**TOWN OF NEWBURGH
PLANNING BOARD
TECHNICAL REVIEW COMMENTS**

PROJECT NAME: SUBDIVISION LANDS OF RIVERA-38 ROSALINE LANE
PROJECT NO.: 22-24
PROJECT LOCATION: SECTION 111, BLOCK 2, LOT 20 & 21
REVIEW DATE: 8 FEBRUARY 2023
MEETING DATE: 16 FEBRUARY 2023
PROJECT REPRESENTATIVE: DARREN DOCE P.E.

SUBDIVISION AND LOT LINE REVISION PLAN

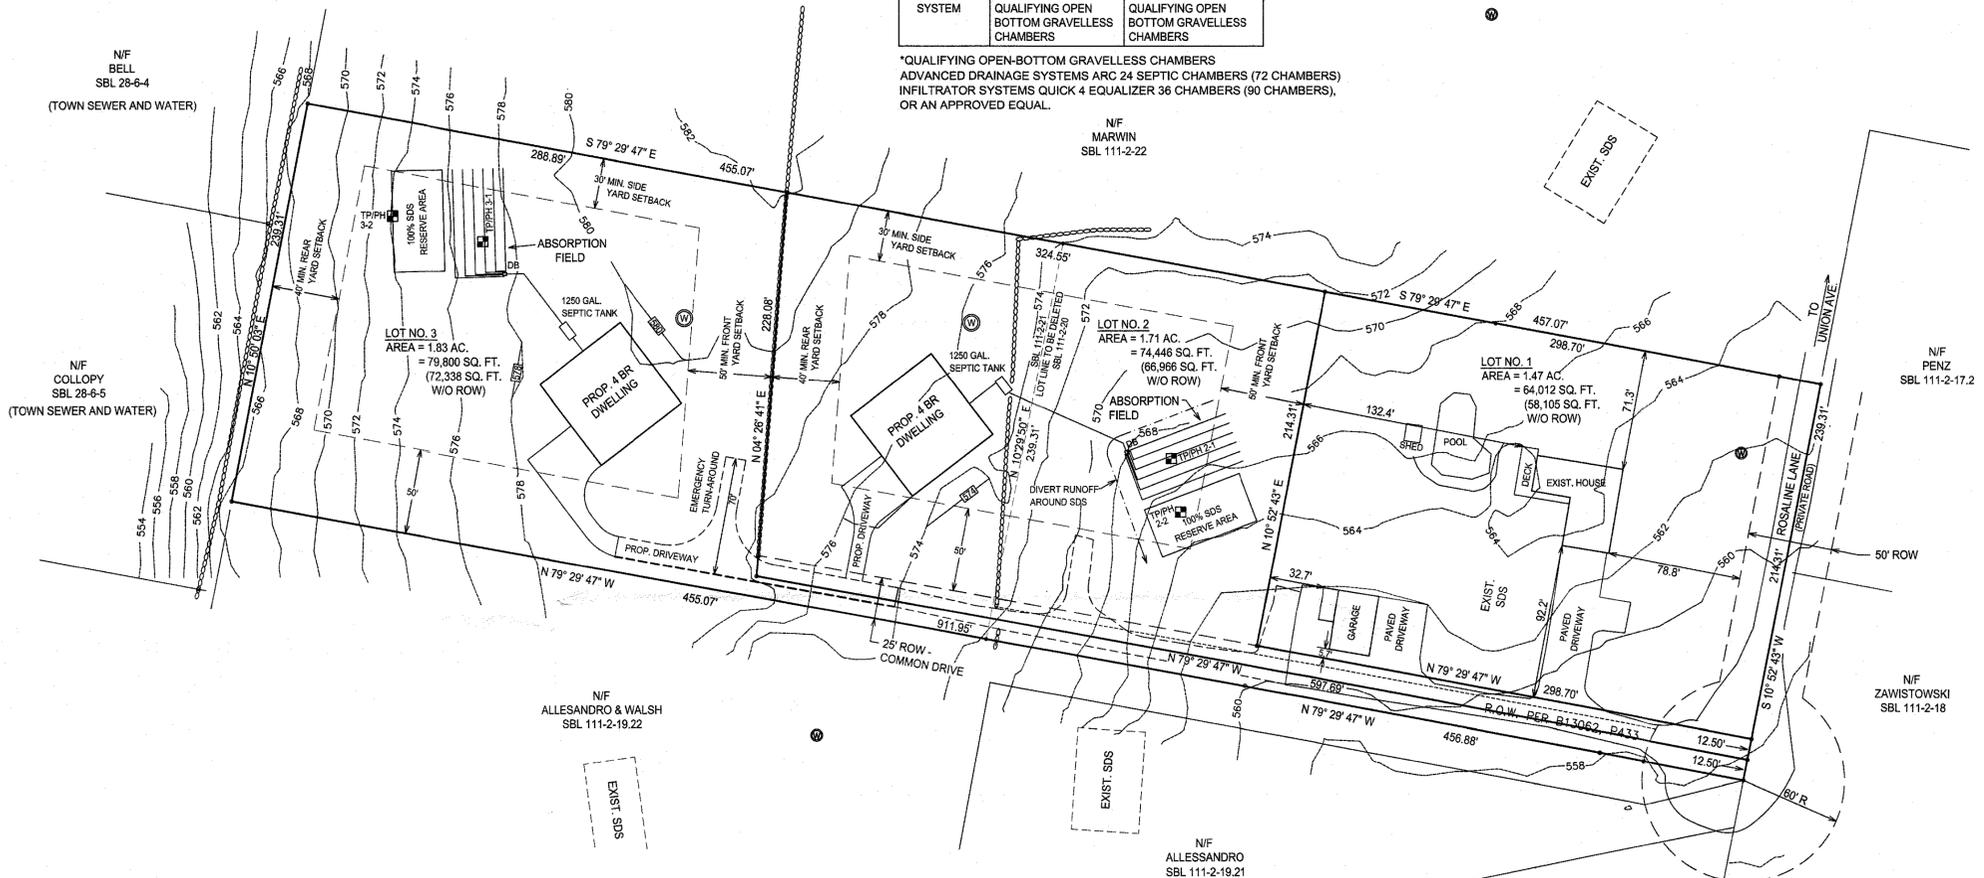
1. Plans have been revised to depict an emergency vehicle turn around at the end of the common driveway on Lot #3.
2. Common Driveway Access and Maintenance Agreement is required. Dominic Cordisco has determined that future subdivision of the lots being serviced by Rosaline Lane, the private road, are permitted.
3. Town Board approval for three lots on the common driveway has been received.
4. Compliance with the Town's Tree Preservation Ordinance must be documented.
5. A detail for the construction of the common driveway should be added to the plan sheets.
